**Project Title:** Northwood & Pinner Cottage Hospital, Pinner Road, HA6 1DE

**Report Reference:** JNY10245-07

- 1.1 This Transport Note provides a supporting technical document to the proposed Minor Material Amendment (S96a) application for changes to the planning approved scheme (Planning Application reference 23658/APP/2021/1296) located at the site of Northwood and Pinner Cottage Hospital on Pinner Road, Northwood.
- 1.2 This note compares the proposed minor changes to that as set out in the approved Transport Assessment (JNY10245-04) and Travel Plan (JNY10048-05) submitted to support the planning application for the development of the site to provide a scheme including a new Health Centre and residential use both with associated car parking and amenity.

Fig 4 Site wide plan extract - MMA Revised proposals

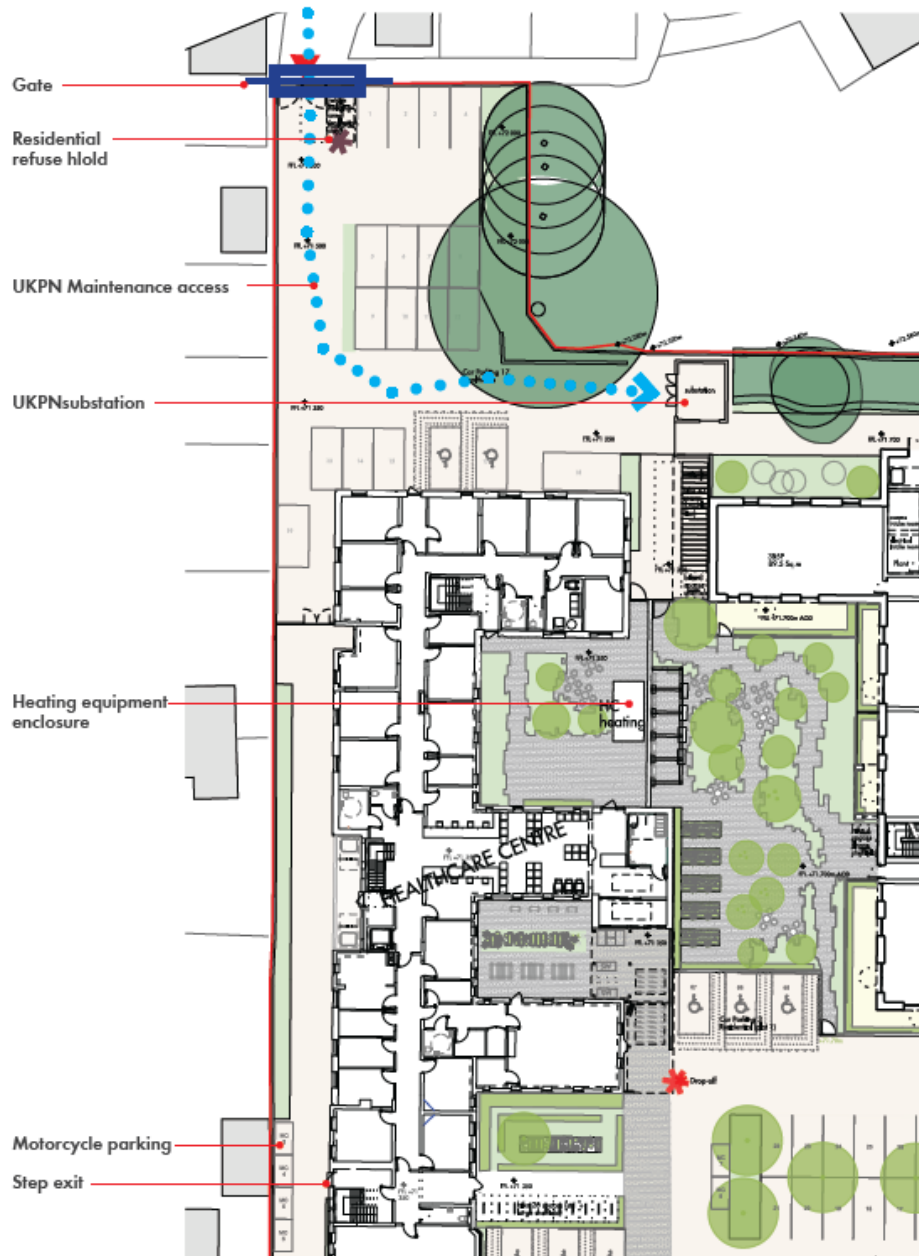
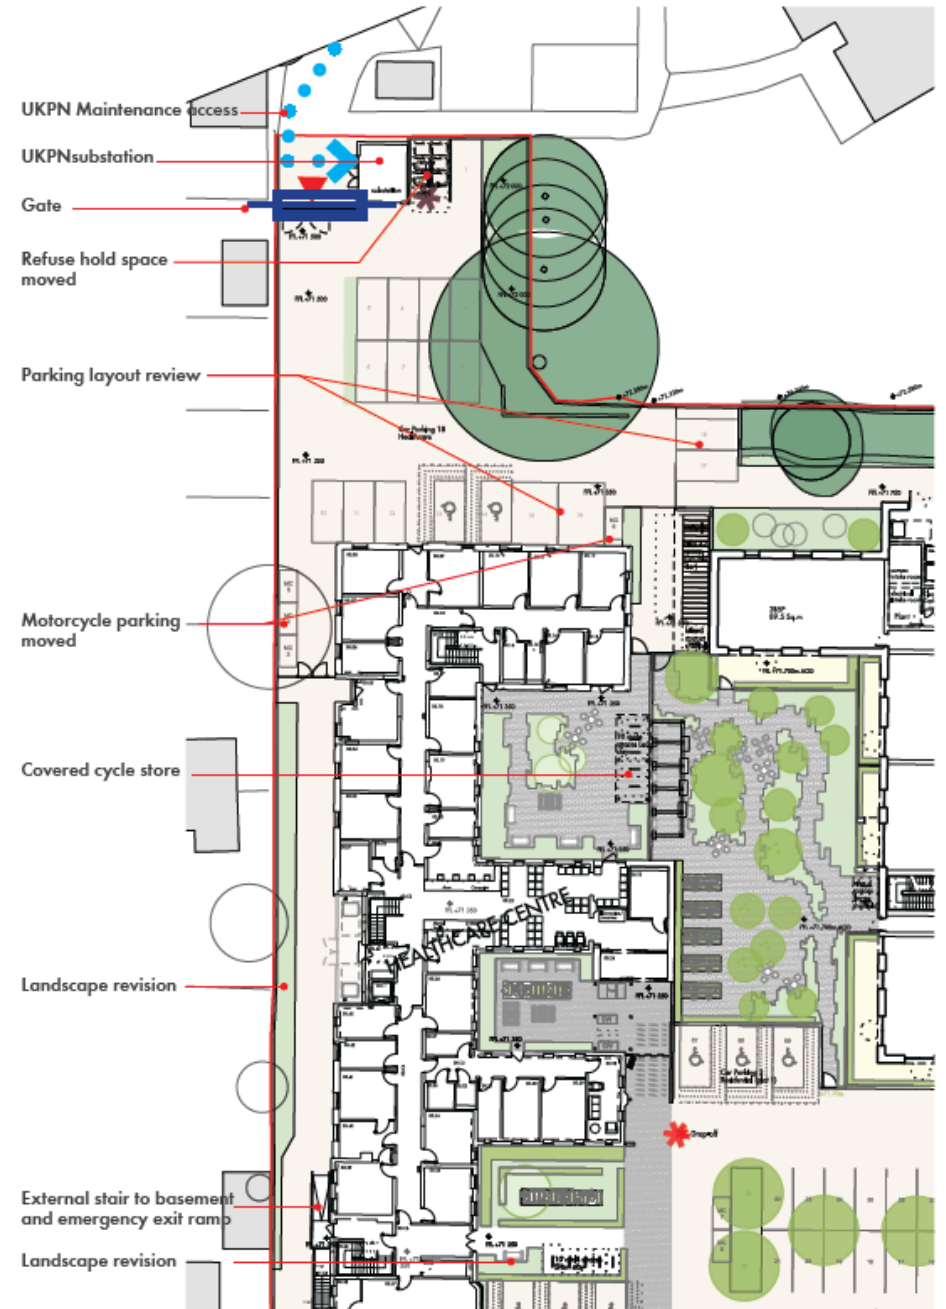
- 1.5 With regards to Transport there are some minor changes that are now proposed which primarily impact the staff parking area accessed from Pinner Road. In addition to the staff parking there are changes to the locations of:

- UKPN Sub-Station
  - Access Gate (Juniper Court/Neal Close Access)
  - Refuse Holding Area
  - Motorcycle Parking
  - Cycle Parking
- 1.6 **Appendix 1** provides a comparison drawing between the Consented scheme and the proposed MMA with annotations highlighting the changes.
-

- 1.7 Early discussions with LBH Design-Out Crime Officer and initial consultation with UKPN has highlighted a conflict of requirements on the type of security locks, operation and management of the vehicle gate to the north car park (staff car park) that in the consented scheme provides access to staff as well as maintenance access to the substation. UKPN require the sub-station is accessible at all times and is not contained behind a security gate access. Therefore, the only satisfactory solution to this is to reposition the substation so that maintenance access is directly from without the need for access to be through a security gate. Therefore, the security gate has been moved and the UKPN sub-station relocated to accent the vehicle access. The relocation of the security gate does not impact of hinder cars or the refuse vehicle on collection days.

- 1.8 The refuse holding area has been relocated 2-3 metres from the planning approved location. The relocation was necessary to allow for the relocation of the UKPN Sub Station closer to the staff car parking access. The relocation of the refuse holding area will not impact the waste operative's ability to safely manoeuvre the waste bins from the refuse holding area to the rear of the refuse vehicle on waste collection day. The drag distance between the holding area and the rear of the refuse vehicle are still with 10 metres.
- 1.9 The vehicle tracking for a refuse vehicle is shown at **Appendix 2**.

- 1.12 RPS and the design team has reviewed the above requirements and sought to reconfigure the car park layout as efficiently as possible in order to re-provide the planning approved 19 car parking spaces. Unfortunately given the above new constraints only 18 car parking spaces can be provided with the space available. The 18 car parking spaces still provides two blue badge parking bays and has been configured based on vehicle tracking.

- 1.15 Four motorcycle parking spaces were approved for the health centre use. These four spaces were located to the side of the health centre and were designated for staff only. These spaces have now been relocated so that they are adjacent the main car parking area to the rear of the site. All motorcycles would access via the Juniper Court/Neal Close access.

- 1.17 The cycle store has now been split in two following feedback from the Access consultant who recommended some cycle parking to be located more centrally within a central enclosed and secure courtyard. Therefore, ten long stay cycle parking spaces have been relocated from the drop off zone to a central courtyard area. The central courtyard will provide covered and secure cycle parking for staff. The overall 20 cycle parking spaces matches the same number as that approved as part of the consented scheme. The minimum required number of cycle parking spaces, based on the cycle parking standards, is 11 spaces therefore the updated scheme is still providing nine spaces over and above the minimum number required.

Title Large Car Swept Path Analysis

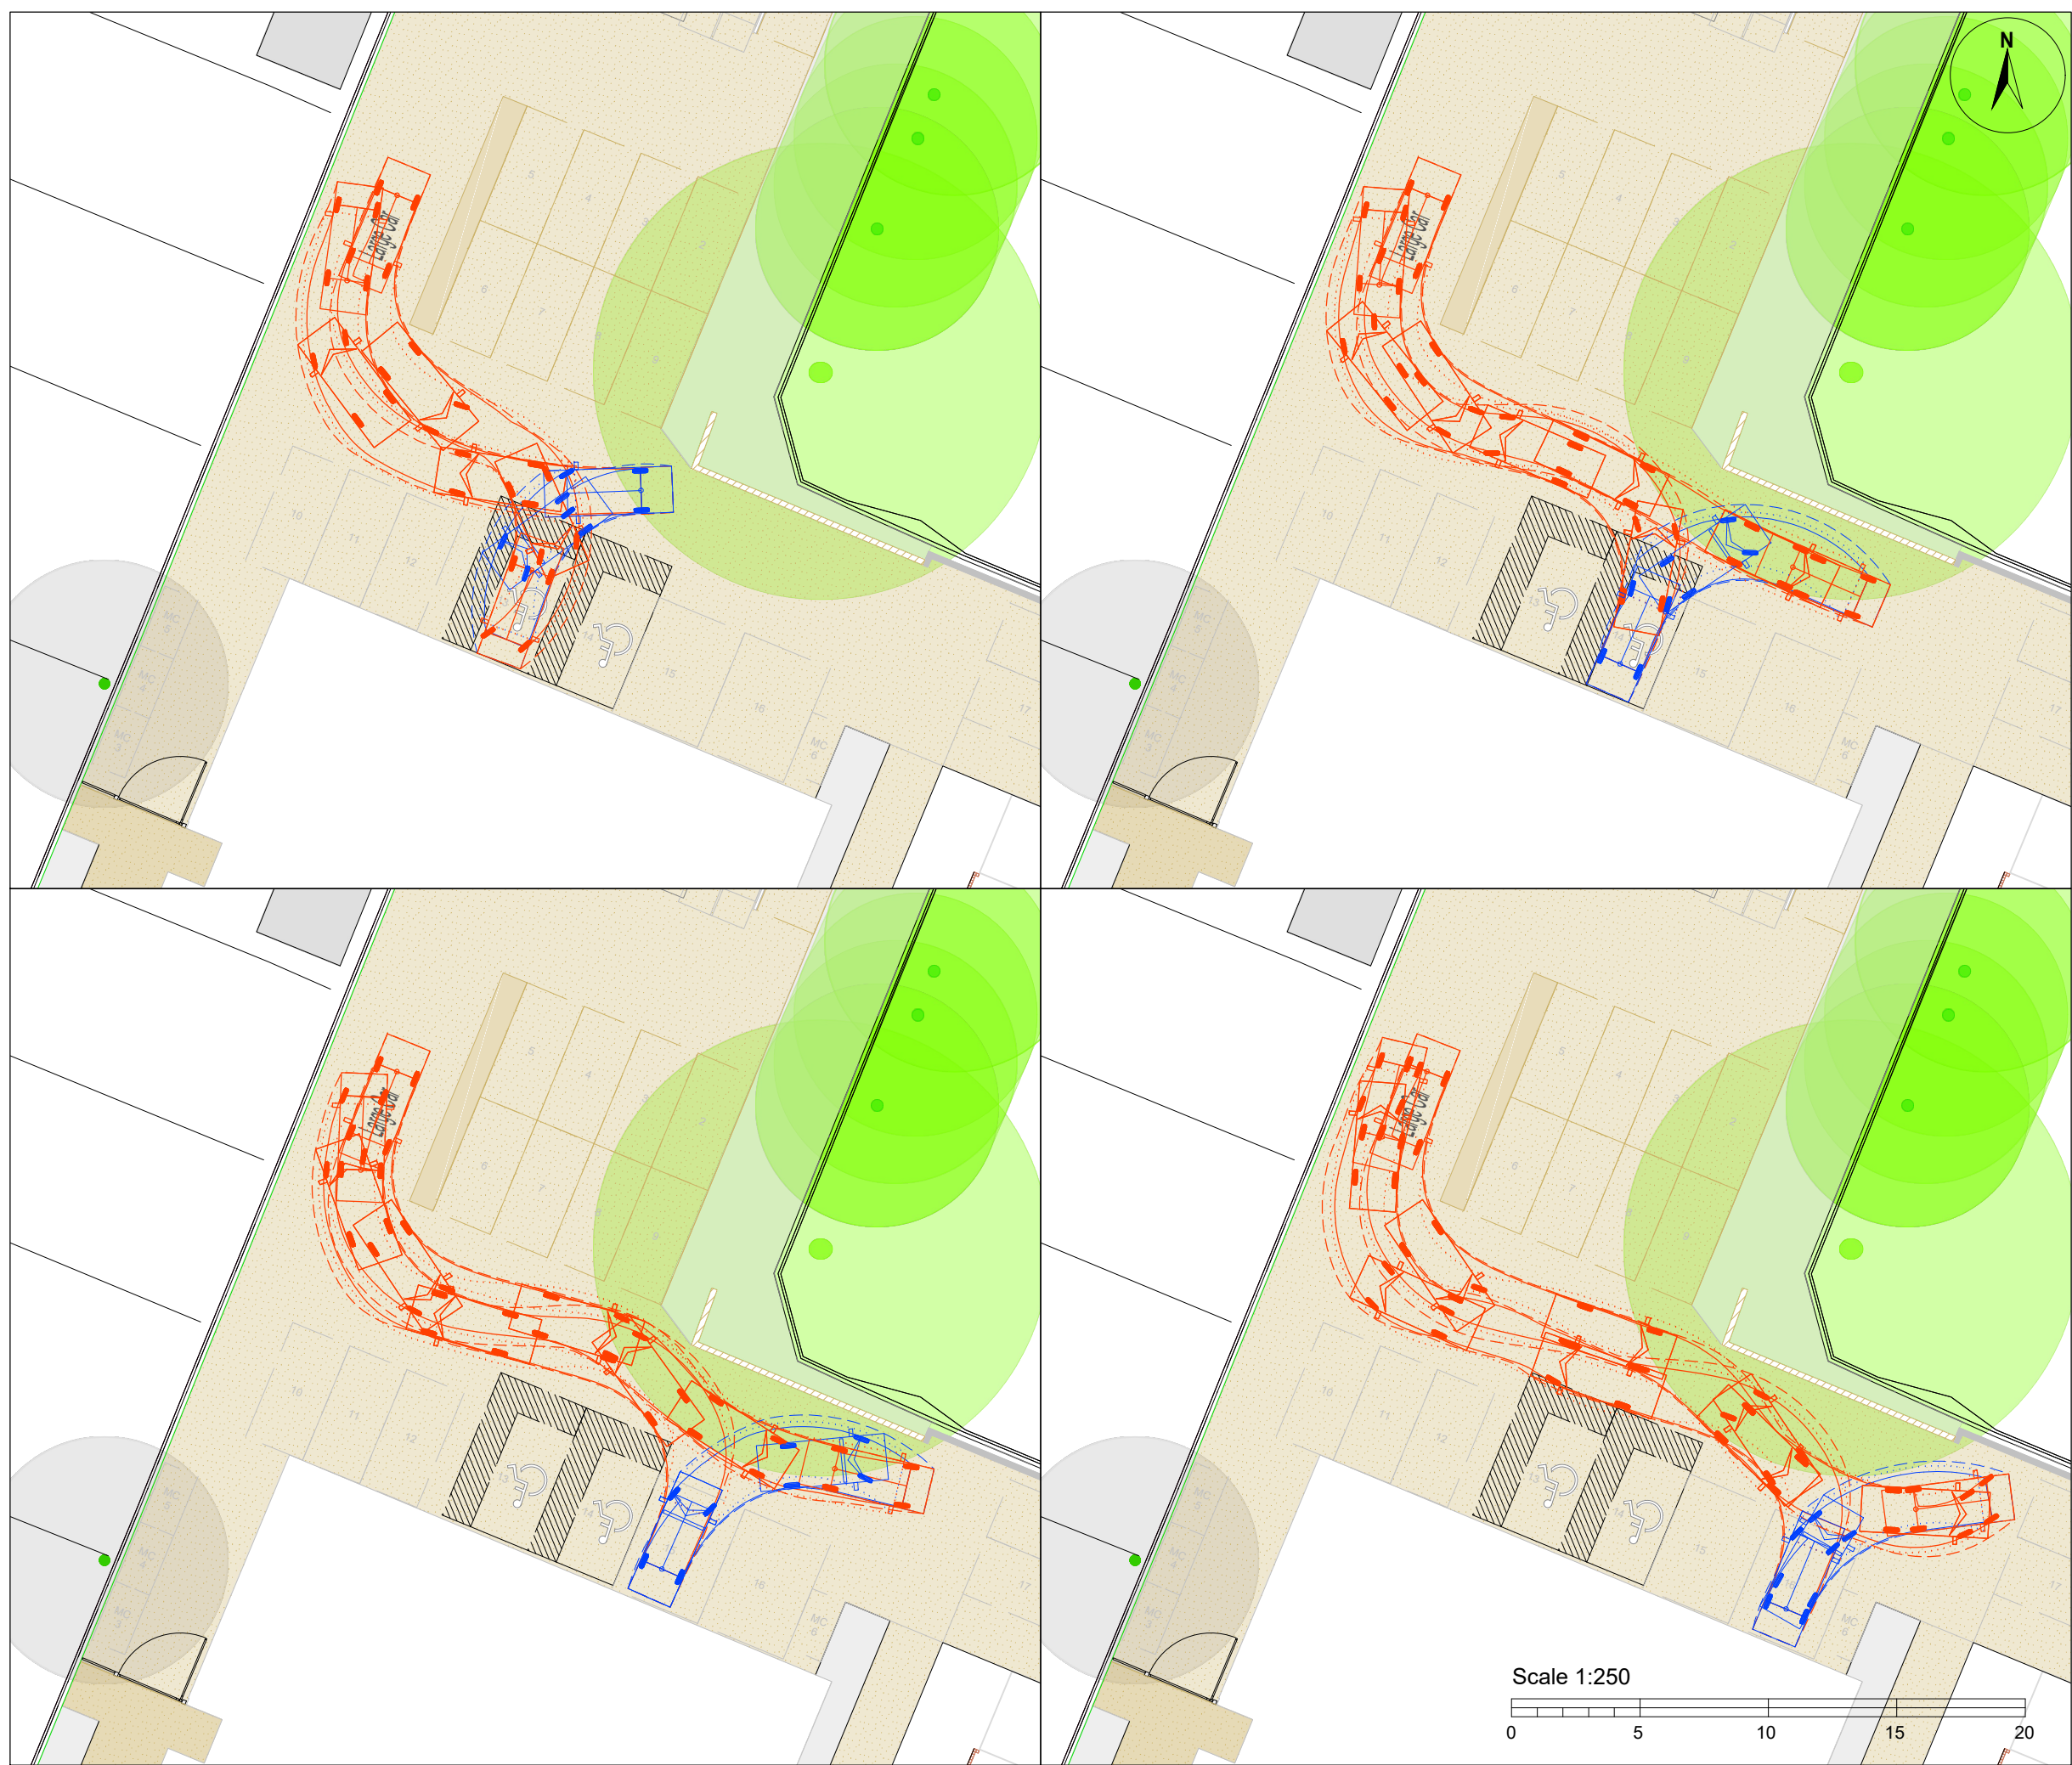
- 1.14 There is a retaining wall required in the car park that does restrict the two car parking spaces to the east of the two blue badge bays. To allow vehicles to enter and importantly reverse these two car parking spaces have been made sufficiently wide and designed based on vehicle tracking (Large car) to ensure that the vehicles can manoeuvre in/out of the bays. The swept path analysis for the car parks is shown at **Appendix 3**.
